# Annex I

## Environmental Impact Assessment

<b>ERA Reference no.:</b>	EA/00025/19
<b>PA Reference no.:</b>	PA/03049/19
<b>Project Title:</b>	A pilot experimental project to renourish the sandy beach at St. George's Bay using sand found on the seabed within the same bay.
<b>Location:</b>	St George's Bay, Triq iz-Zejtun, Triq Ghar Dalam, Birzebbuga
<b>Screening date:</b>	May 2019

**Figure 1:** Proposed beach nourishment, indicating culvert and run-off drainage (Source: Project Description Statement (PDS))

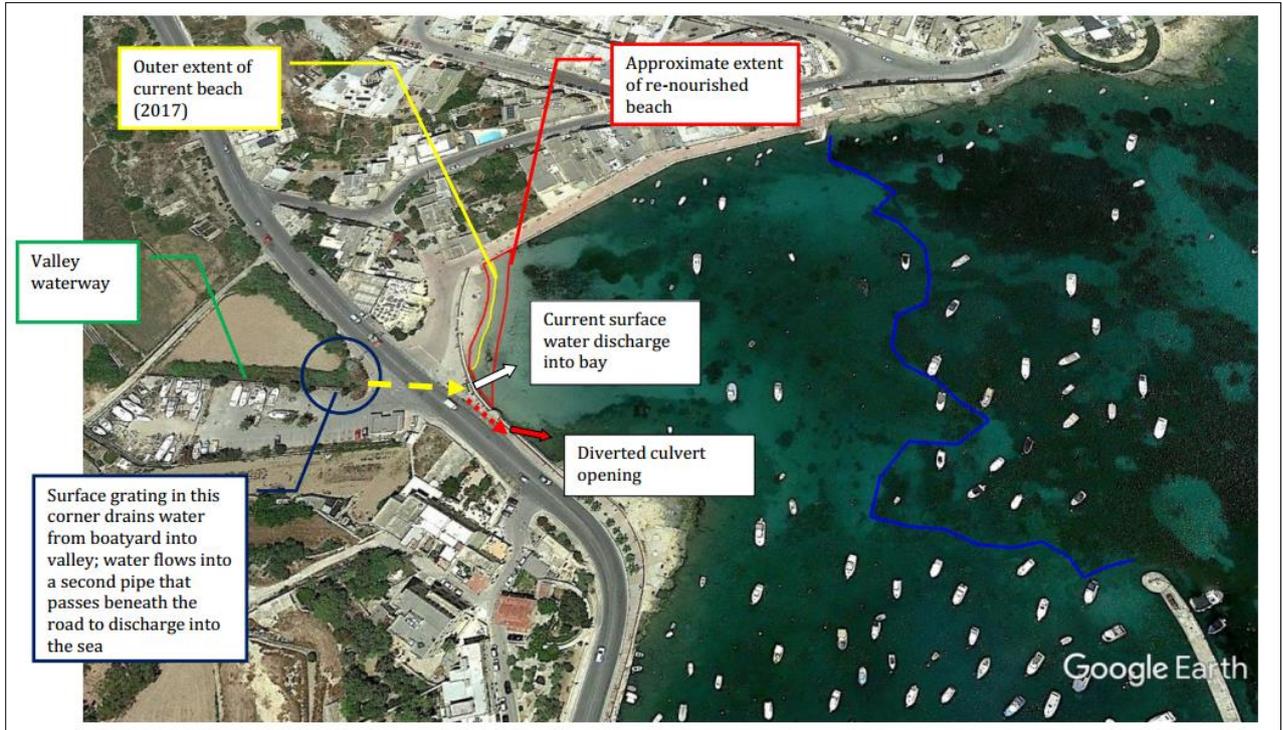
- 1.2 The beach is subject to the natural dynamics of the bay, however the existing culvert has been identified as an additional source of erosion. Due to the construction of the roads/promenade and associated hard surfacing, which has covered part of the historic beach surface, the connection of the valley to the beach has been obstructed and water run-off is diverted through a culvert which discharges run-off into the bay (see Figure 2 and 3). According to the PDS, this discharge eroded the beach such that the dry beach area is currently restricted to the north-western corner of the bay. This concern is being tackled through a separate application (DN/00310/19) which has been decided already by the Planning Authority, and which will relocate the said culvert away from the sandy beach along the west side of the bay.

4.4 The proposed dredge-and-fill exercise for the nourishment of the beach is likely to create physical changes to the seabed within the perimeter of the borrow area and to the nearshore seabed due to extension of the dry beach and its submerged slope.

- (i) In terms of the physical characteristics of the beach and inshore seabed area and the natural dynamics of the bay, the nourished beach is to follow the bathymetric profile of the seabed and shall not extend beyond the sustainable width, as indicated in part 5 of the Addendum to the PDS, in order to avoid significant losses of the beach fill;

**Figure 4:** Proposed borrow area for sediment, including a buffer zone (Source: PDS)

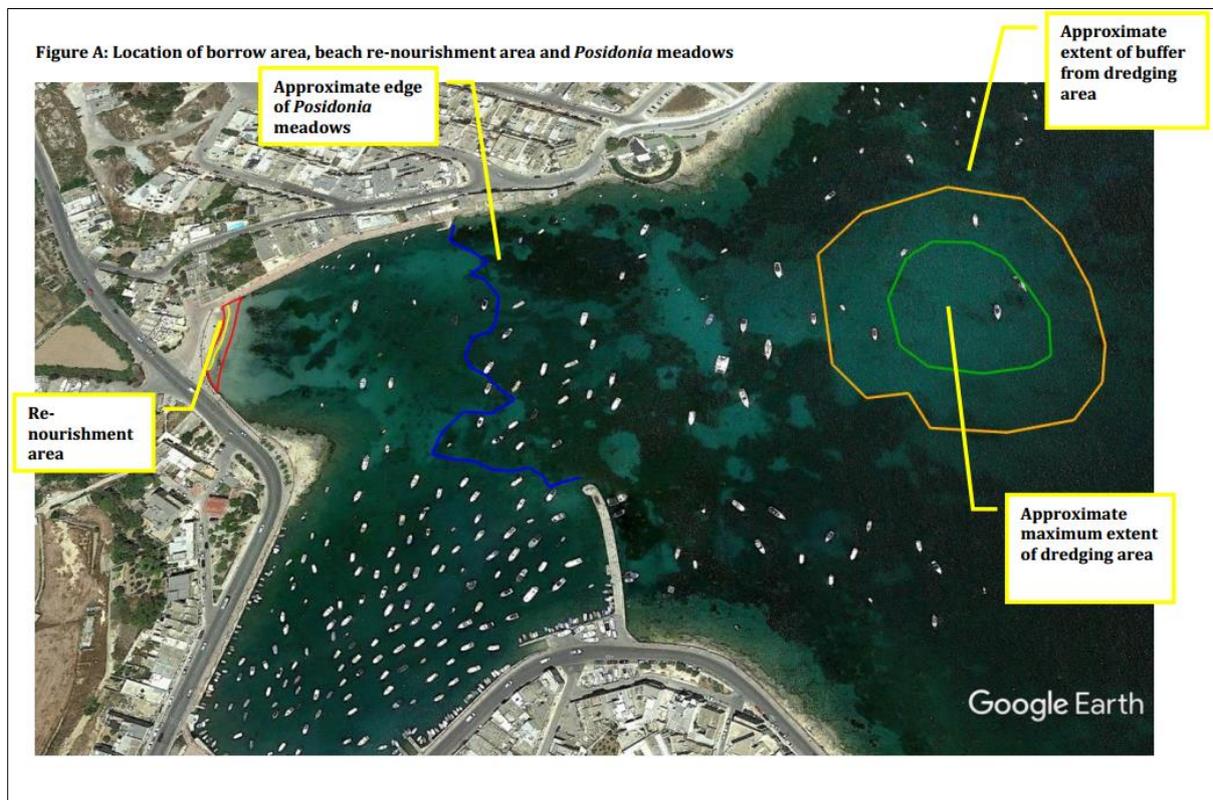
- 4.6** According to the PDS, not more than 2,200 m<sup>3</sup> of sediment would be required to nourish the beach. Following a sand pricking exercise and sediment quality analysis, it has been determined that a borrow area can be defined within the bay itself which contains enough sediment to nourish the beach with the required volume. In order to retain a secure distance from the surrounding Posidonia meadows, a buffer zone has been included (see Figure 4), as already indicated above.

- 4.11** The proposed dredging works are envisaged to obliterate or disturb the present bare sands habitat and its benthic communities (e.g. infauna) within the borrow area. The presence of *Posidonia* beds in the immediate surrounding of the borrow area is of concern, in view of potential direct construction-phase impacts, however such impacts are being mitigated by the inclusion of a buffer area between the *Posidonia* beds and the actual area for sand winning.

- (ii) The dredging of sediment shall be restricted to the identified borrow area only, respecting the buffer zone as shown in part 5 of the Addendum to the PDS, in order to avoid direct impacts on the surrounding Posidonia meadows, protected through the Flora, Fauna and Natural Habitats Protection Regulations (S.L. 549.44);
